FORM APPROVED
OMB NO. 1004-0135
Expires: July 31, 2010**SUNDRY NOTICES AND REPORTS ON WELLS**
Do not use this form for proposals to drill or to re-enter an abandoned well. Use form 3160-3 (APD) for such proposals.5. Lease Serial No.
NMNM0499988

☒ Oil Well ☐ Gas Well ☐ Other8. Well Name and No.
NASH UNIT 43H

XTO ENERGY INCORPORATED

13. Describe Proposed or Completed Operation (clearly state all pertinent details, including estimated starting date of any proposed work and approximate duration thereof. If the proposal is to deepen directionally or recompleat horizontally, give subsurface locations and measured and true vertical depths of all pertinent markers and zones. Attach the Bond under which the work will be performed or provide the Bond No. on file with BLM/BIA. Required subsequent reports shall be filed within 30 days following completion of the involved operations. If the operation results in a multiple completion or recompleat in a new interval, a Form 3160-4 shall be filed once testing has been completed. Final Abandonment Notices shall be filed only after all requirements, including reclamation, have been completed, and the operator has determined that the site is ready

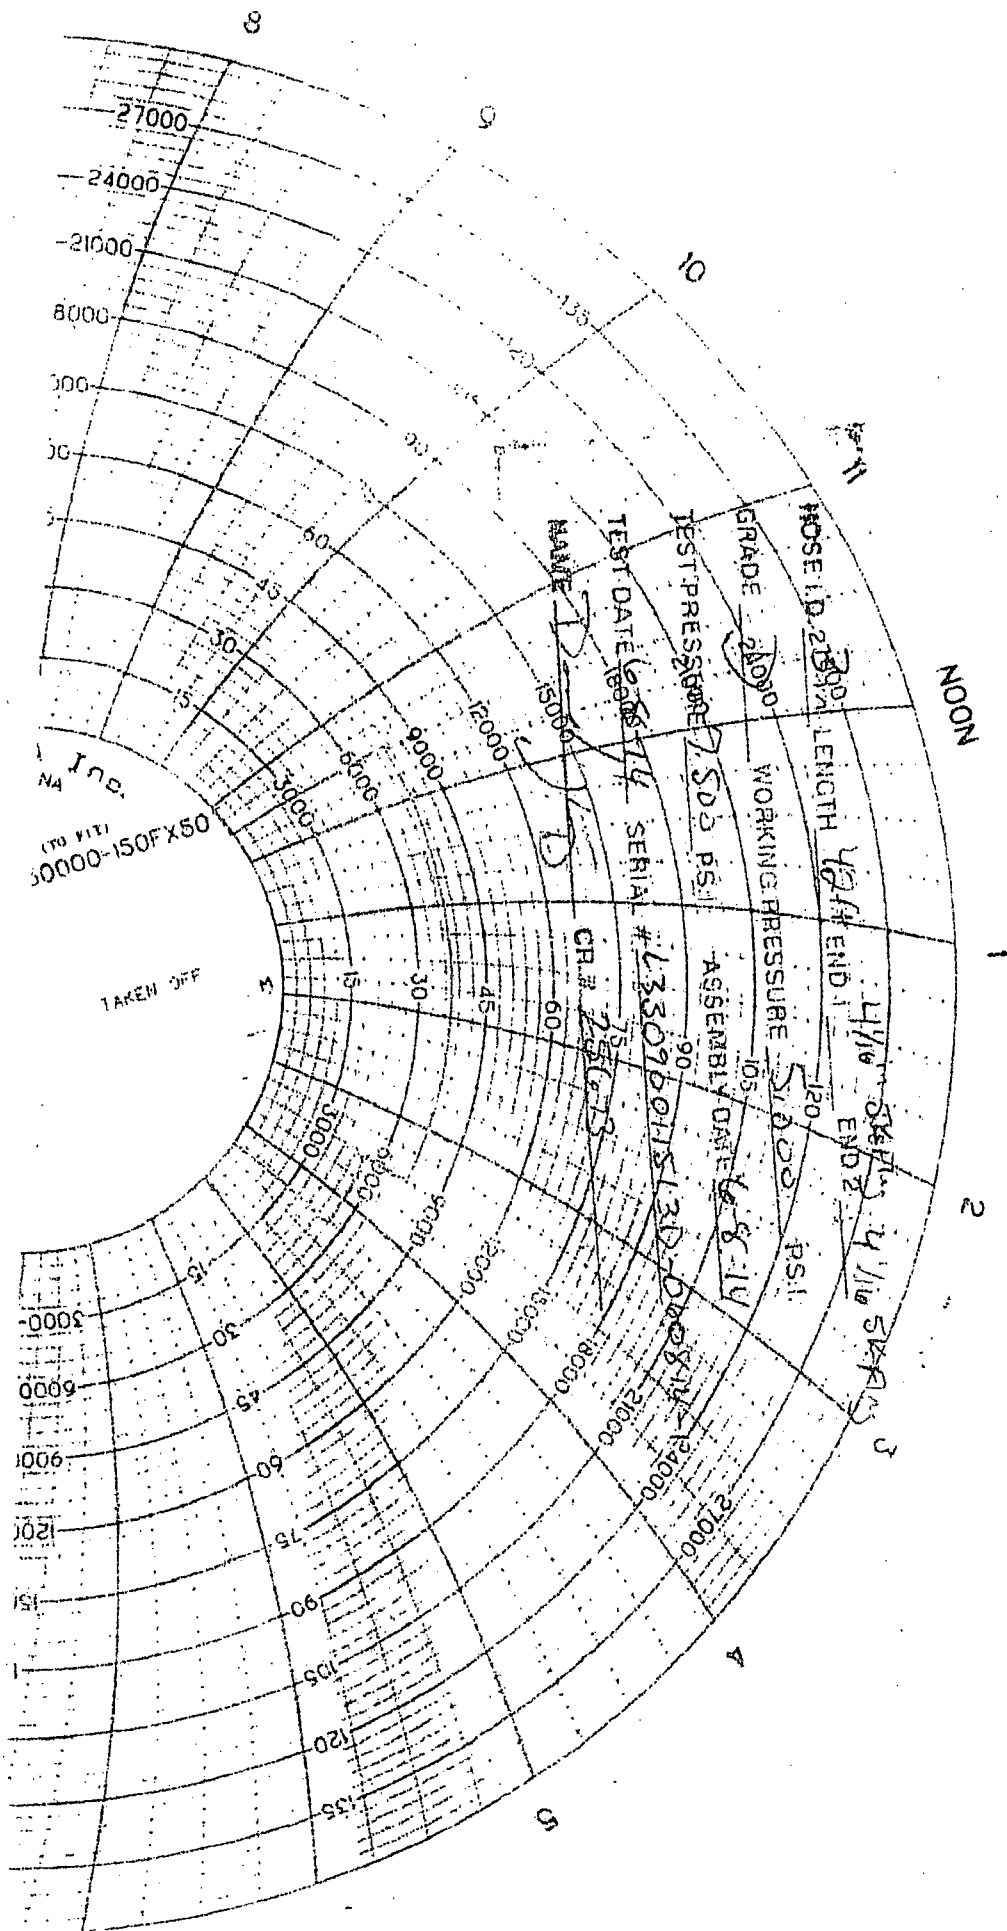
XTO Energy requests a variance from the requirement to use straight hard line as the choke line and instead use a flex hose. Pioneer 33 is outfitted with a Gates E&S flex hose rated to 5,000 psi working pressure (serial # D-060814-1). See attached for test certificate and copy of the pressure test chart.

2. Variance approved to use flex line from BOP to choke manifold. Check condition of flexible line from BOP to choke manifold, replace if exterior is damaged or if line fails test. Line to be as straight as possible with no hard bends and is to be anchored according to Manufacturer's requirements. The flexible hose can be exchanged with a hose of equal size and equal or greater pressure rating. **Anchor requirements, specification sheet and hydrostatic pressure test certification matching the hose in service, to be onsite for review. These documents shall be posted in the company man's trailer and on the rig floor.** If the BLM inspector questions the straightness of the hose, a BLM engineer will be contacted and will review in the field or via picture supplied by inspector to determine if changes are required (operator shall expect delays if this occurs).
